Comments on the PennDOT Determination of Effects Report on the Headquarters Road Bridge

A report prepared for the Delaware Riverkeeper by:

Mark L. Stout, PhD
Mark L. Stout Consulting

14 December 2015

Figure 1
Police sketch of 24 October 2003 crash, vehicle skidding
on icy surface into Jersey barrier

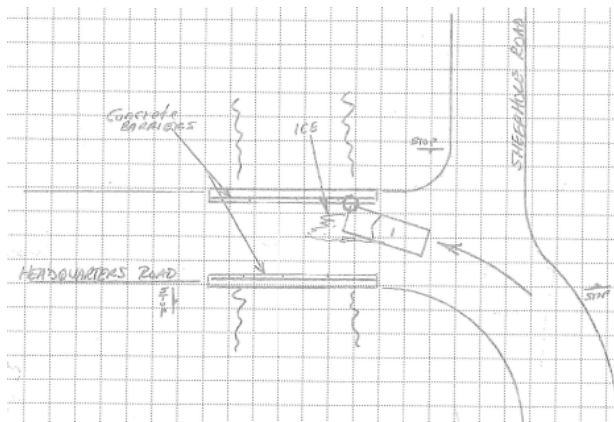
- 24 October 2003 – A vehicle driving westbound on Headquarters Road attempted a left turn onto the bridge and slid on an icy road surface on the bridge, resulting in contact with the bridge wall (see figures 1 and 2).
- 1 April 2006 – An unregistered, uninsured vehicle left the scene of the crash while the driver and passengers were out for a “joyride.” Details of the crash are minimal but do indicate that contact was made with the Jersey barrier on the bridge.
- 7 May 2006 – A motorcyclist reported losing control of his eastbound motorcycle on loose gravel as he entered the bridge (see figures 3 and 4).

While the width of the bridge (a 10-foot cartway at the time) may have been a minor factor in these crashes, it does not appear that bridge width was the primary causal factor in any of these crashes.

Figure 5
Police sketch of 6 July 2007 crash, impact on the fence
to the west of the bridge

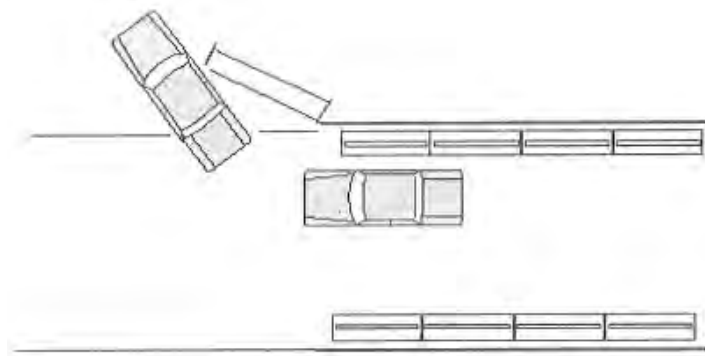
A fourth crash, on 6 July 2007, appears to have been near the bridge. A vehicle driving westbound was reported as having made contact with a fence or wall near the bridge. Based on the limited description and the police sketch (figure 5), the

vehicle probably made contact with the fence on the western end of the bridge (figure 6).
